SUBJECT: APPROVAL OF CHANGE ORDER #3 RADCLIFF ELEMENTARY

Change Order

PROJECT (Name and address):
Renovation to Radcliff Middle School -
Phase I
1145 S. Dixie Boulevard
Radcliff, Kentucky 40160

CHANGE ORDER NUMBER: 003

ENLARGED RESTROOM PLAN - PROPOSAL REQUEST #7 - DRAWING PR7.1

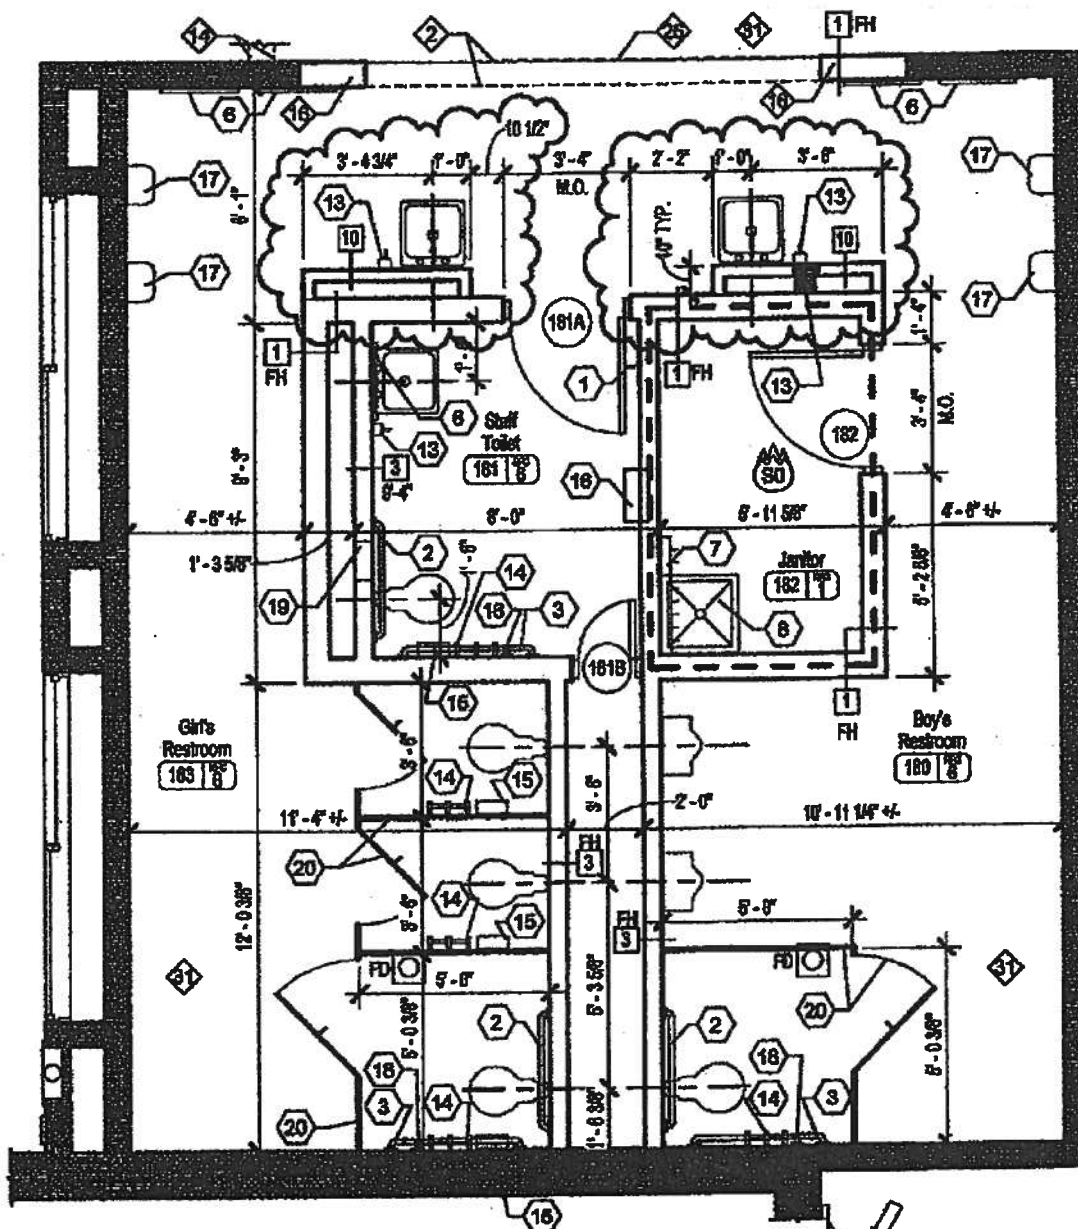
| 1. | (COR 10 / PR 007) Add 4" CMU pilasters at restrooms 180 and 183 in order to conceal the existing steel column, which was not located on the original construction documents.

Provide a cost proposal for two (2) 4" CMU pilasters at Boy's Restroom #180 and Girl's Restroom #183 per the attached drawing. This change is in response to RFI #19. The change is a result of a found condition and is meant to correct an existing structural steel column.

REFER TO ENLARGED RESTROOM PLAN "A", SHEET
 A2.2 IN THE ORIGINAL CONTRACT DOCUMENTS.

0935
 RFI No 18

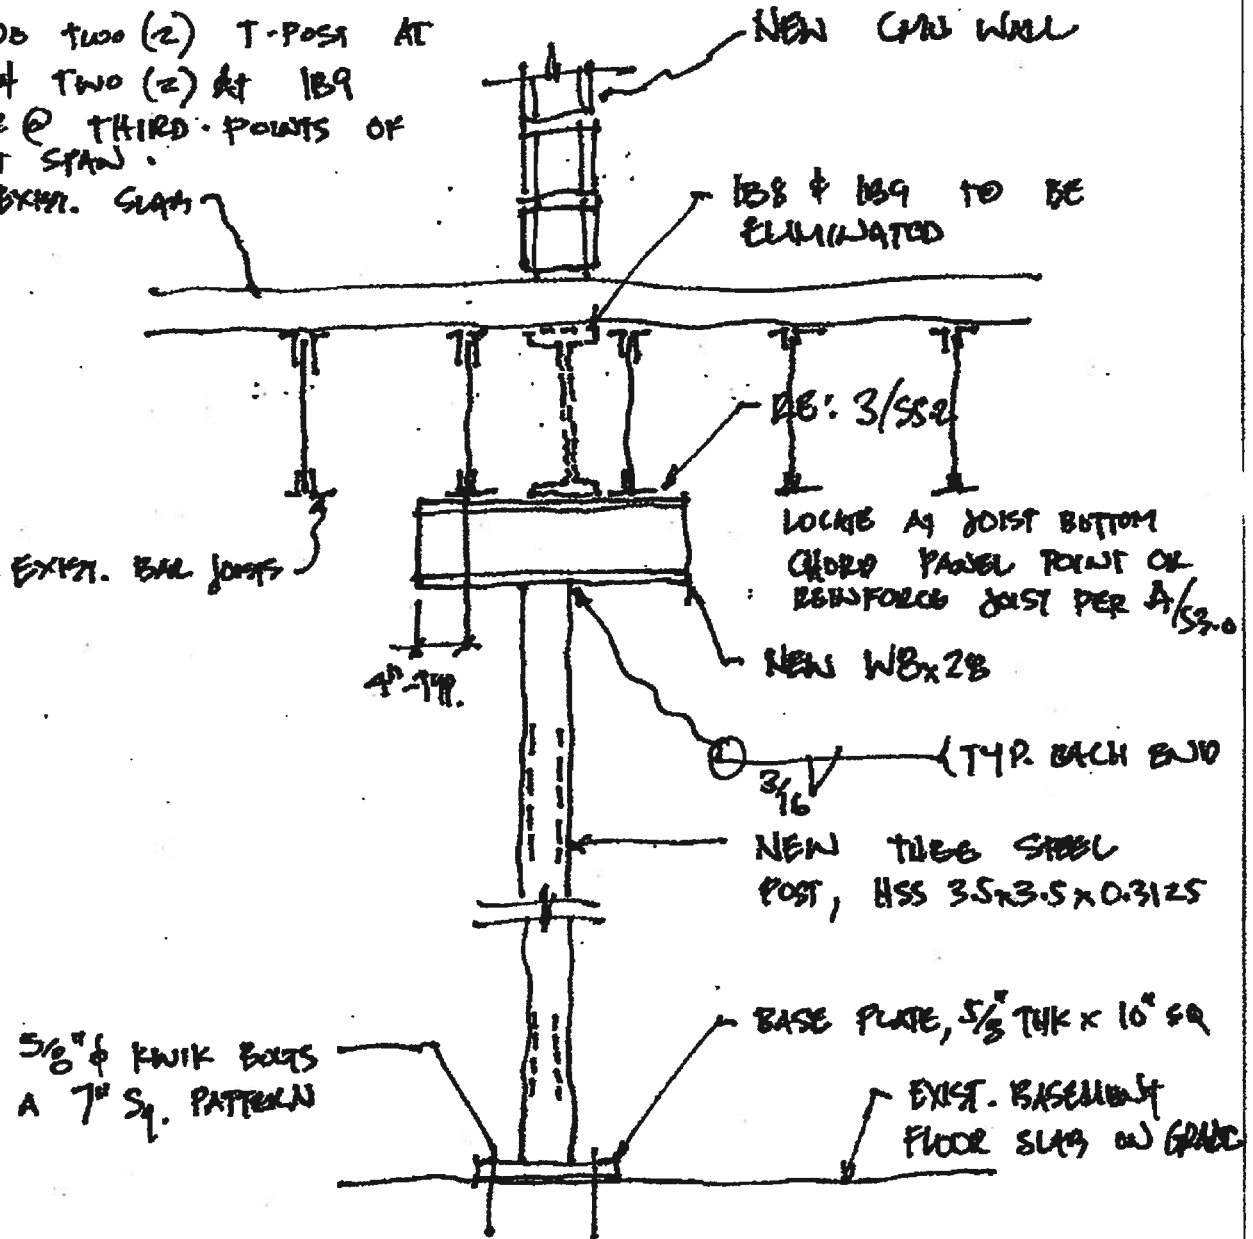
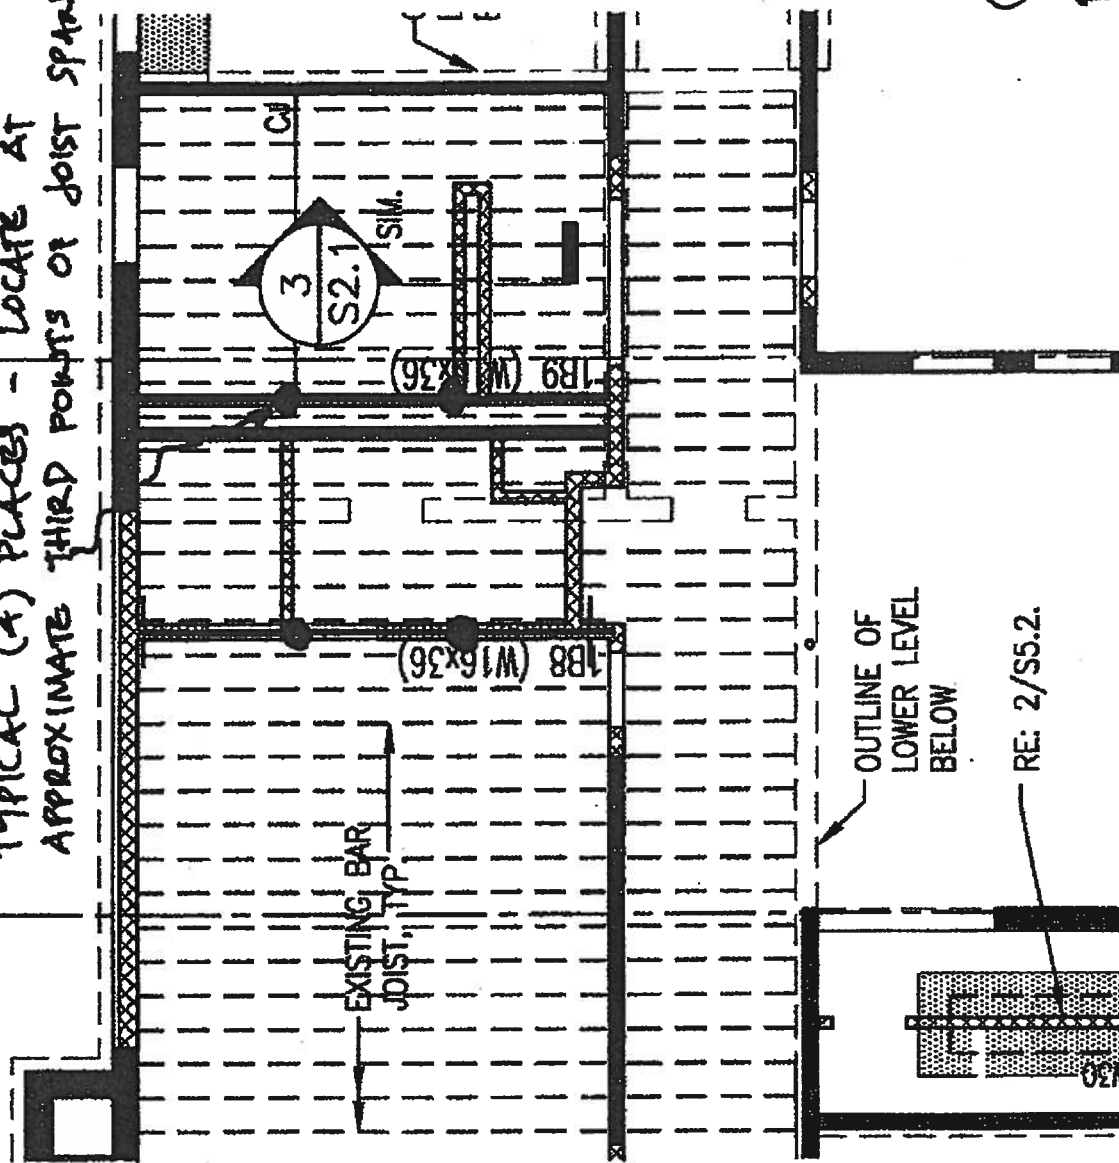
| 2. | (COR 11 / RFI 18) Modify the existing floor support at beam 1B8 due to found conditions contradictory to original construction documents.

Reference Sheet S1.1 The (W16x36) 1B8 scheduled to support the new 8" CMU wall on the first floor conflicts with three existing feeder conduits and one 3" gas line scheduled to remain. Would it be possible to support the new wall by adding angle to existing bar joist similar to detail 5/S5.2 ? Currently the new 8" wall is scheduled to be full height, an additional consideration may be to stop the wall at 10'-0" AFF to decrease the load below.

PROVIDE TWO (2) T-POST AT
1B8 & TWO (2) AT 1B9
LOCATE @ THIRD POINTS OF
JOIST SPAN.
EXIST. SLAB

NEW 'T'-POST TO REPLACE
 BEAMS 1B8 & 1B9 - SEE SKETCH
 TYPICAL (4) PLACES - LOCATE AT
 APPROXIMATE THIRD POINTS OF JOIST SPANS

RFI No. 16

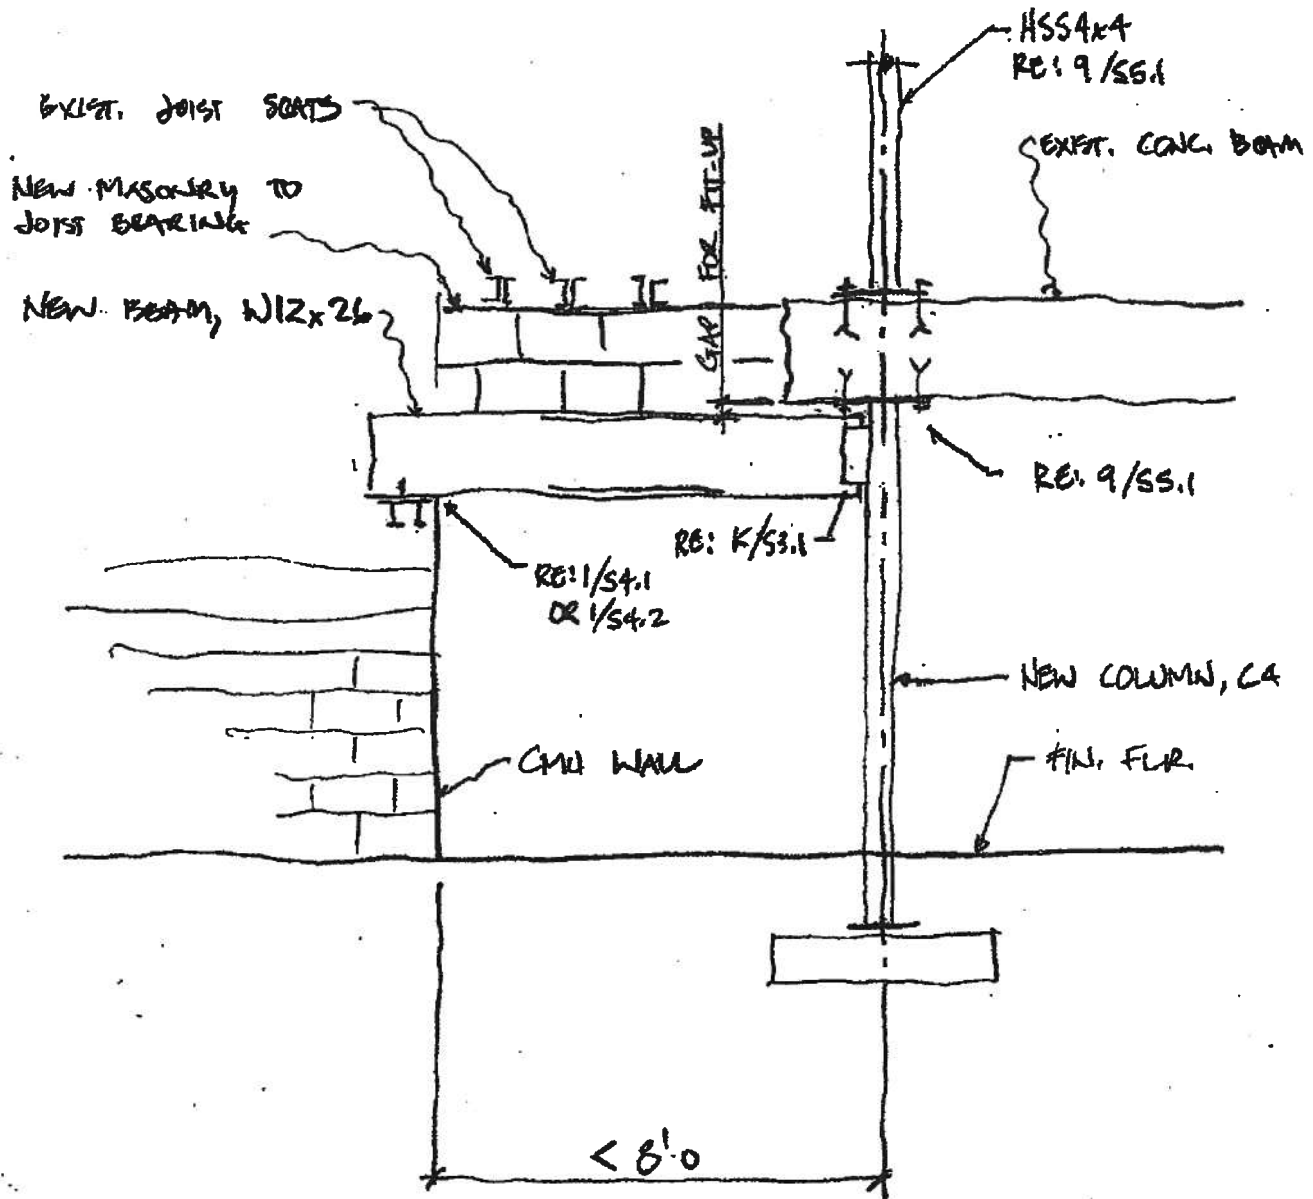
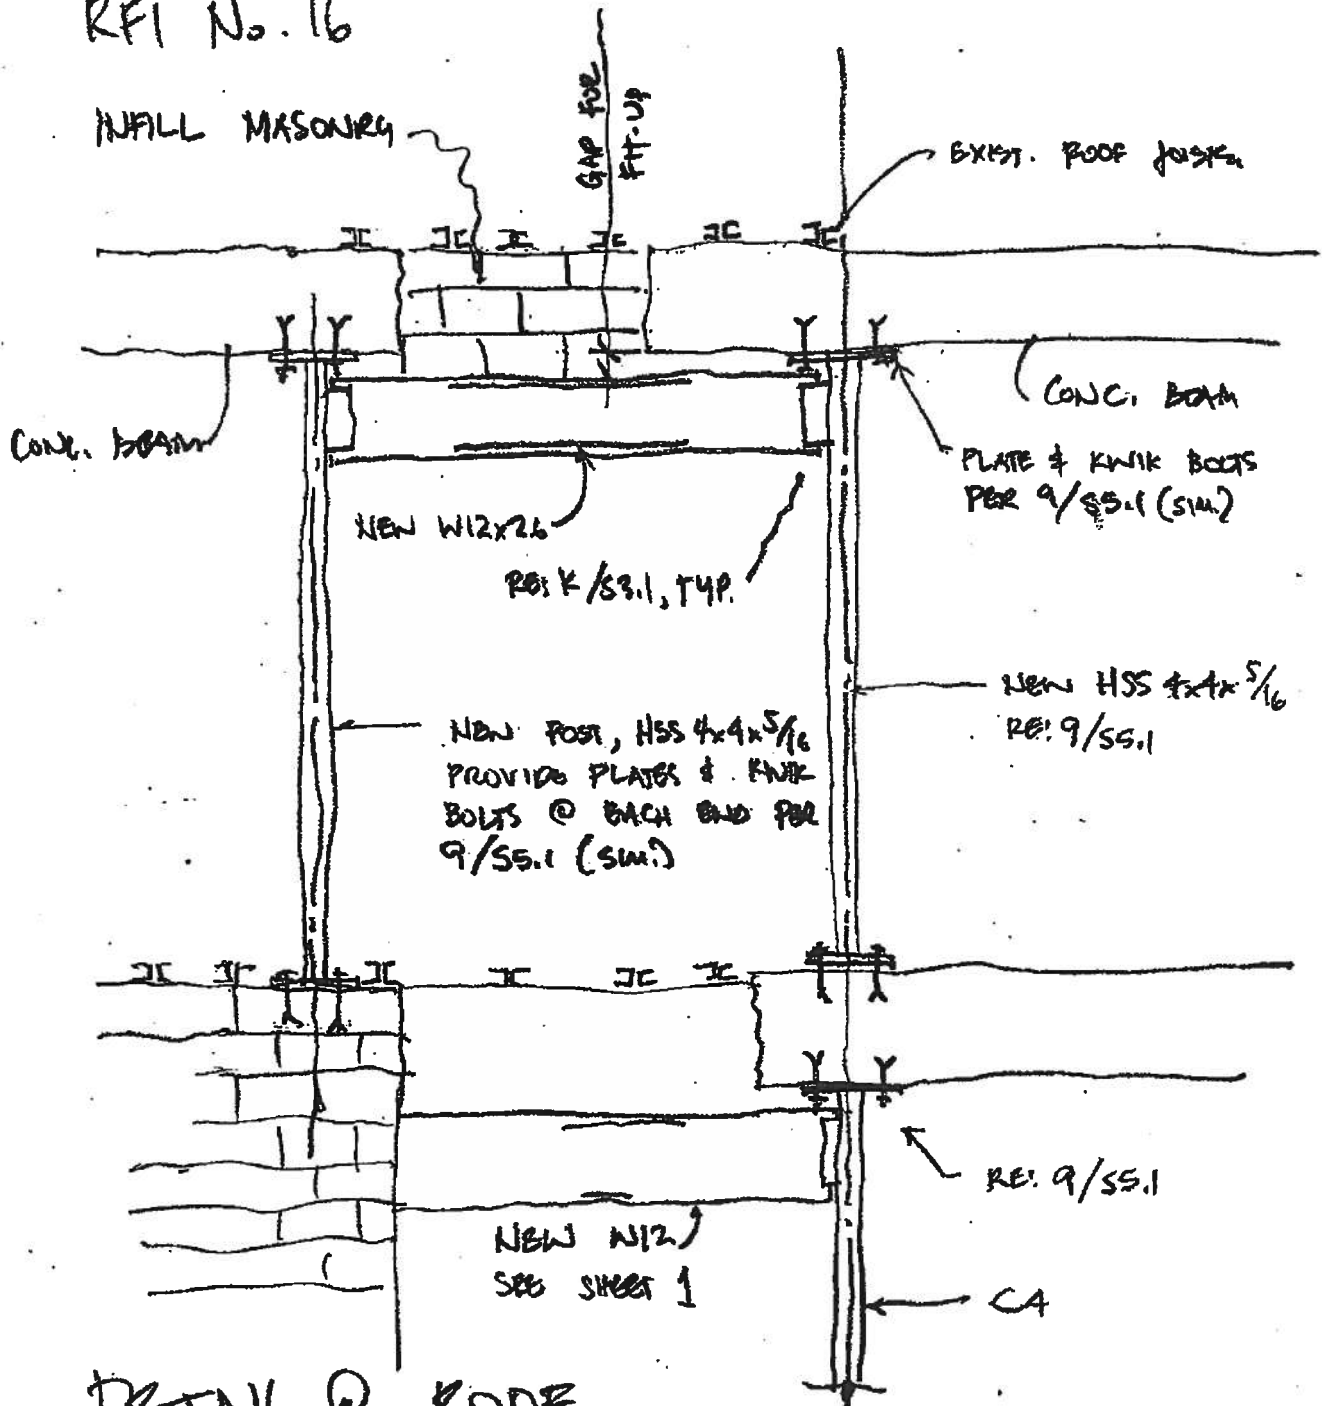
Reference Sheet S.13 2nd floor framing plan column line 4 between B&D. The existing beam shown does not exist. Please advise how we are to proceed.

Detail 9/S5.1 The existing concrete beam at the roof line has a 3'-4" void filled with conc. Brick supporting existing joist. The wall below is to be removed. Please provide detail for supporting these joist

Sheet S1.3 indicates post P2 Ref: detail F/S3.1 near column line B & 4. Should this post be located between 2nd floor and roof line? If so what is to support the post?

- 1.) Fab and Install two W12 x 26 beams at Approximately 10' each
- 2.) Field weld three connection plates to previously installed columns.

M1.2R	DATE: 03/31/10		PROJECT NO: 0895
	DRAWN:		
	PROJECT NAME: RENOVATION TO RADCLIFF MIDDLE SCHOOL - PHASE 1		
	PROJECT LOCATION: RADCLIFF, KENTUCKY

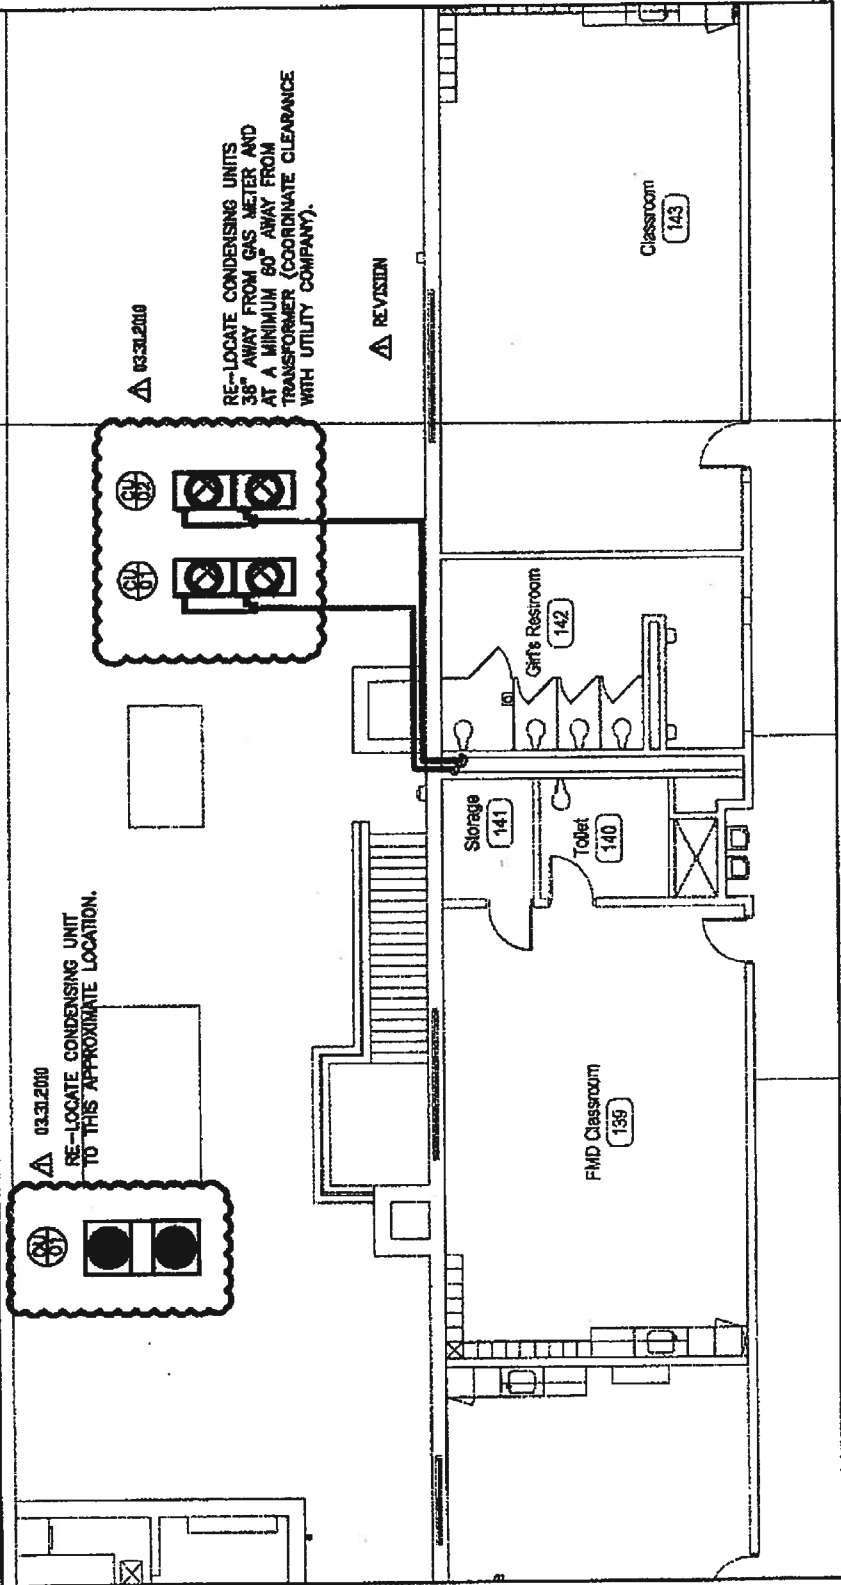
| 5. | (PR 005) Shift the VRF condensing units approximately 5 feet in order to avoid close proximity to the existing gas meter and transformer and the adjacent exterior classroom window.

Shift the VRF condensing units approximately 5 feet as indicated on the attached drawing, in order to avoid close proximity to the existing gas meter and transformer and the adjacent exterior classroom window.
